TRANSMISSION **722.6 as of 1.8.97**

15 Caps

P27.19-0321-06

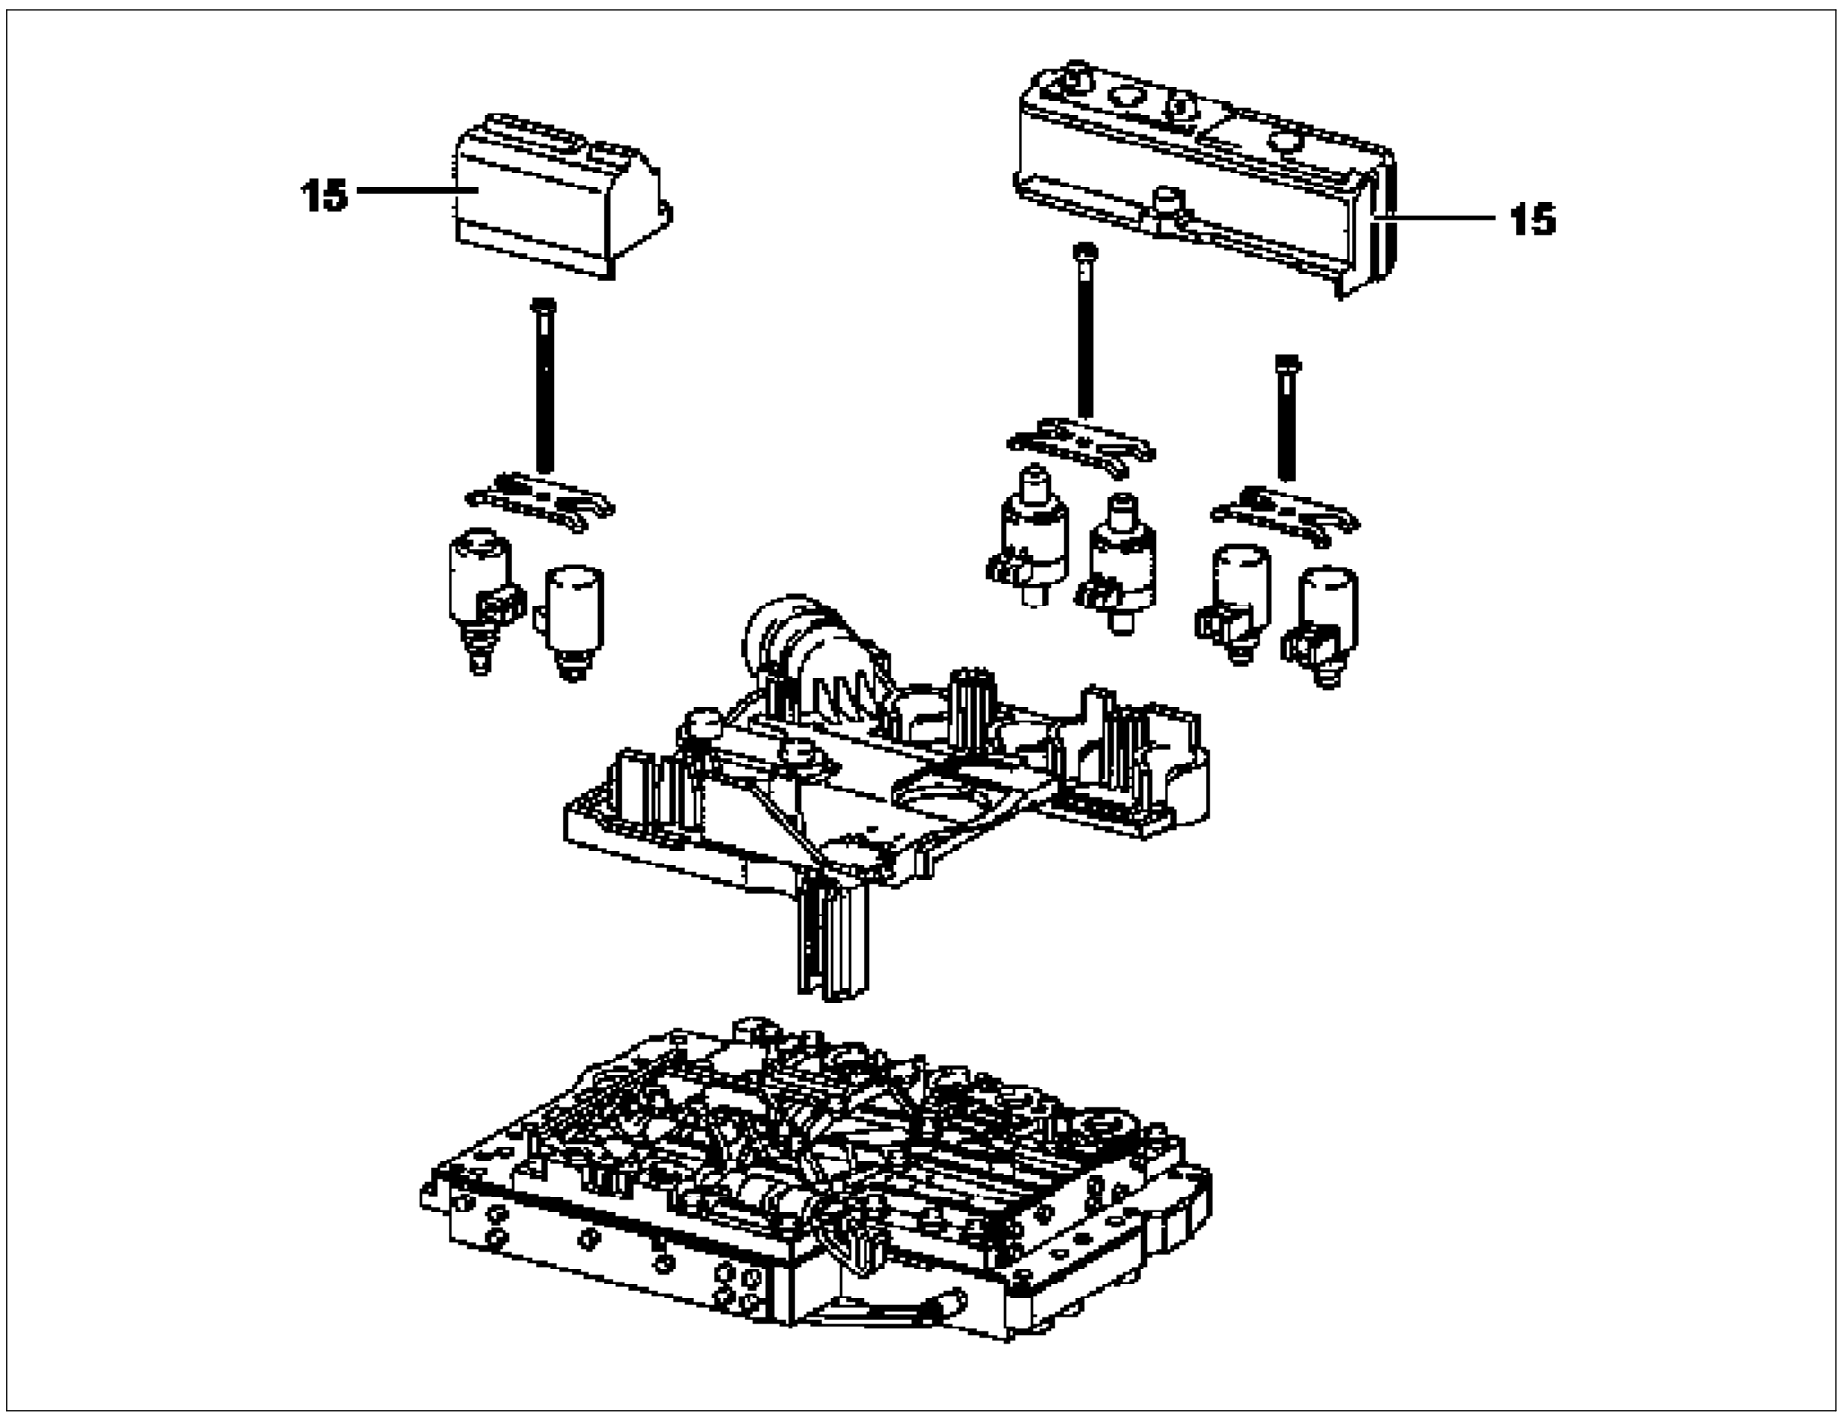
To prevent a short-circuit due to metal abrasion or metal shavings on the contact tongues of the solenoid valves, all solenoid valves are covered with caps.
